UNITED STATES PATENT AND TRADEMARK OFFICE

10/801,838

Office Action Summary	Application No. 10/801,838	Applicant(s) UEDA, NAOHIRO	
	Examiner Abul Kalam	Art Unit 2814

Claim Rejections - 35 USC § 103

FIG. 2

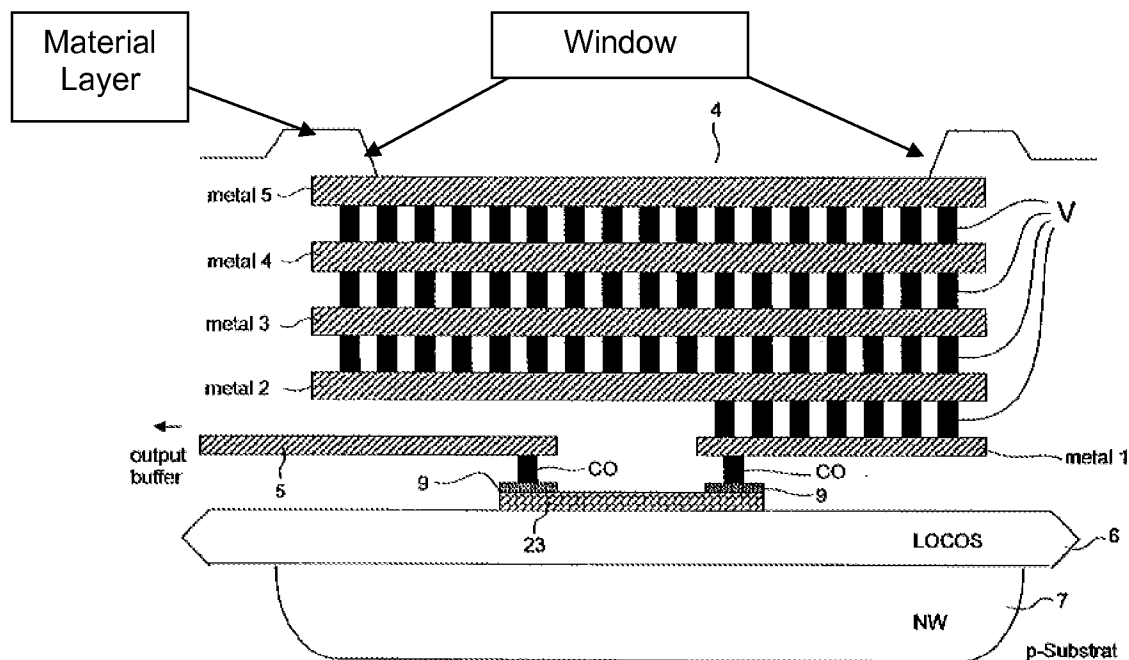
With respect to **claim 1**, **Reiner** teaches a semiconductor apparatus (**Fig. 2**) comprising:

a semiconductor substrate (**p-Substrate, Fig. 2, ¶ [0036]**);

a metal wiring layer (**metal 2, Fig. 2, ¶ [0036]**) formed over the semiconductor substrate;

a material layer (**see depiction of Fig. 2 below**) formed over the metal wiring layer (**metal 2**) and having a window therein;

a first electrode pad (**4, Fig. 2**) formed over the semiconductor substrate (**p-substrate**), and exposed through said window for providing contact between said semiconductor apparatus and external circuitry (**Fig. 2, ¶ [0036]**: **it is implicit that bond pad 4 provides contact between the semiconductor apparatus and external circuitry**);

explicitly disclosing wherein said first electrode pad being formed over said array of resistive elements such that said first electrode pad extends transversely across said array.

Regarding **claim 22, Reiner** teaches wherein the first electrode pad (**4, Fig. 2**) is formed on an uppermost metal wiring layer (**metal 5**) of the semiconductor apparatus, and wherein said uppermost metal wiring (**metal 5**) is substantially entirely cover by said material layer (**Fig. 2**).

FIG. 2

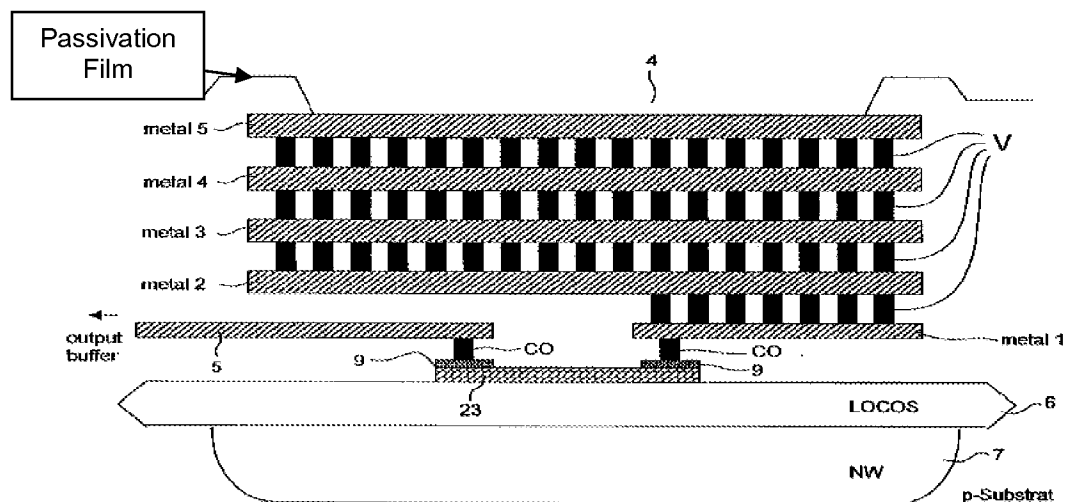
Thus, **Takasu** discloses all the limitations of the claim with the exception of explicitly disclosing wherein the electrode pad extends transversely across the array of strip-shaped resistive elements; and a passivation film formed over an uppermost metal wiring layer of the semiconductor apparatus and having a window arranged to expose

the electrode pad. However, **Zuniga** teaches an analogous semiconductor apparatus wherein an electrode pad (**514/515**, **Figs. 5 and 6**) is formed over an array of resistive elements (**passive resistors**) such that said electrode pad (**514/515**) extends transversely across said array (**¶ [0052]**, **Figs. 5 and 6**). Furthermore, **Reiner** teaches an analogous semiconductor apparatus including a passivation film (**see Fig. 2 below**) former over an uppermost metal wiring layer (**metal 5**) of the semiconductor apparatus and having a window arranged to expose an electrode pad (**4**).

Therefore, it would have been obvious to one of ordinary skill in the art at the time of the invention, to incorporate the teachings of Zuniga and Reiner, into the apparatus of Takasu, for the disclosed intended purpose of saving chip space (**Zuniga: ¶ [0049]**) and improving the functionality and reliability of the device (**¶ [0036]-[0037]**).
